PROJECT MANUAL FOR: **Power Plant -  
Brick and Mortar Repairs**

PROJECT NUMBER: **CP230671**

2023-04-06

END OF ADDENDUM #1

**A4 ENLARGED STAGING PLAN**  
SCALE: N.T.S.

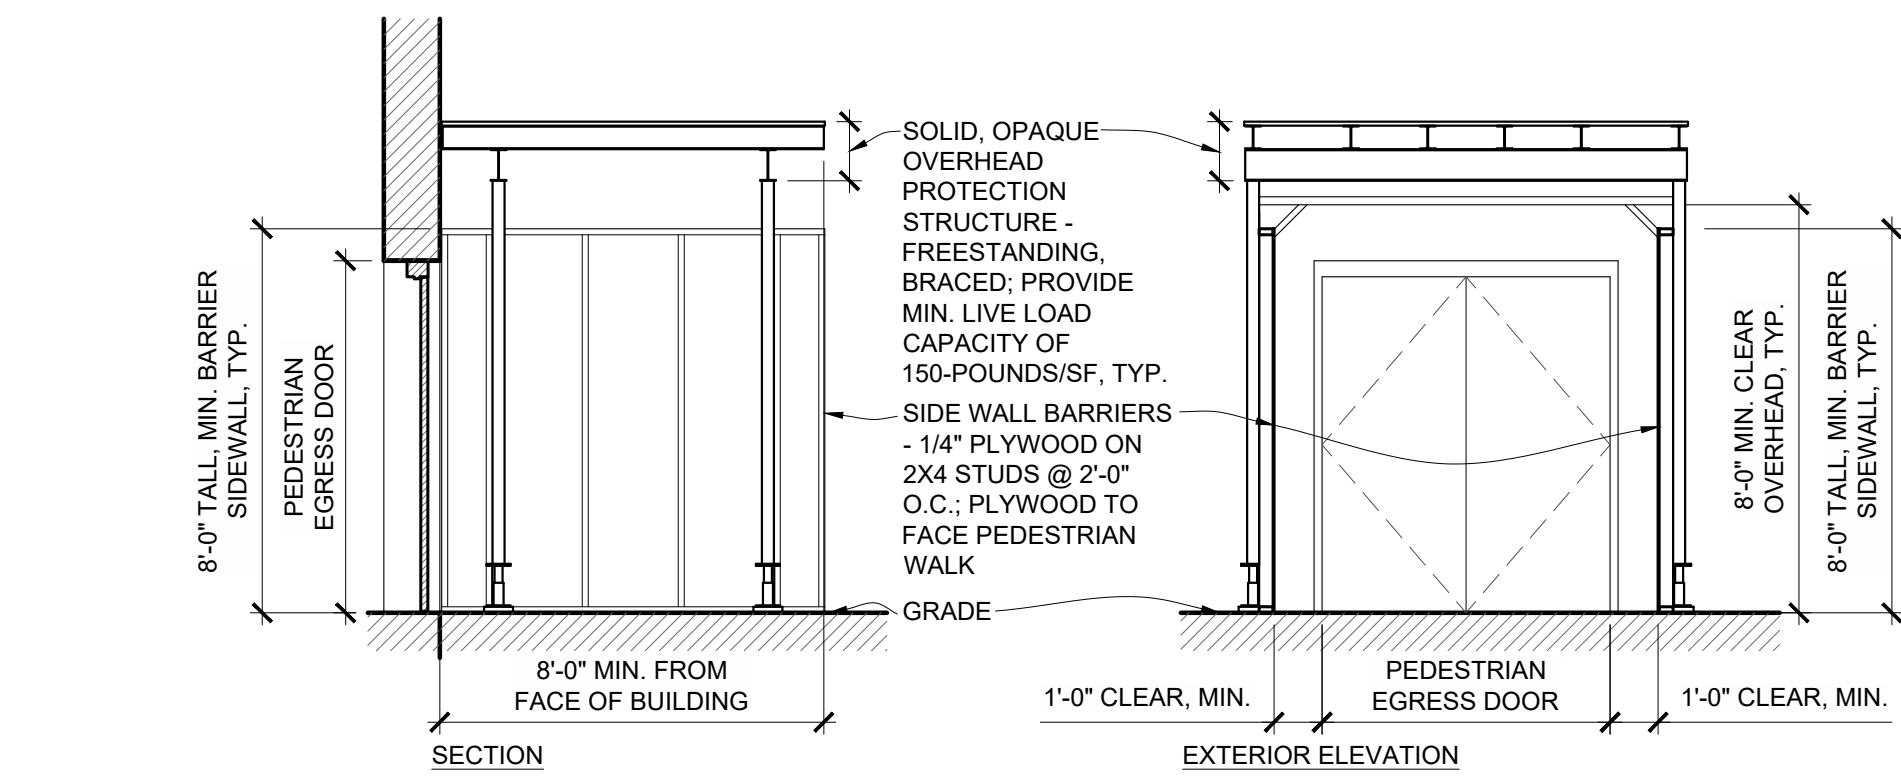
- Questions asked during the 2023-04-04 pre-bid meeting include:
  - Does the existing fire hydrant (FH) at the south side of the Boiler House require protected access?

- G003 – Staging Plans and Protection Details:
  - Add Scope-of-Work Notes 13 and 14 addressing the existing fire hydrant and standpipe connection, both of which are located on the south side of the Boiler House.
  - See attached revised sheet G003.

RESPONSE: Yes, provide overhead protection at the FH. Maintain open access should the fire department need the FH.

- PROVIDE OVERHEAD PROTECTION AT EXISTING FIRE HYDRANT. MAINTAIN FIRE DEPARTMENT ACCESSIBILITY TO FIRE HYDRANT.
- EXISTING STANDPIPE CONNECTION; MAINTAIN FIRE DEPARTMENT ACCESS.
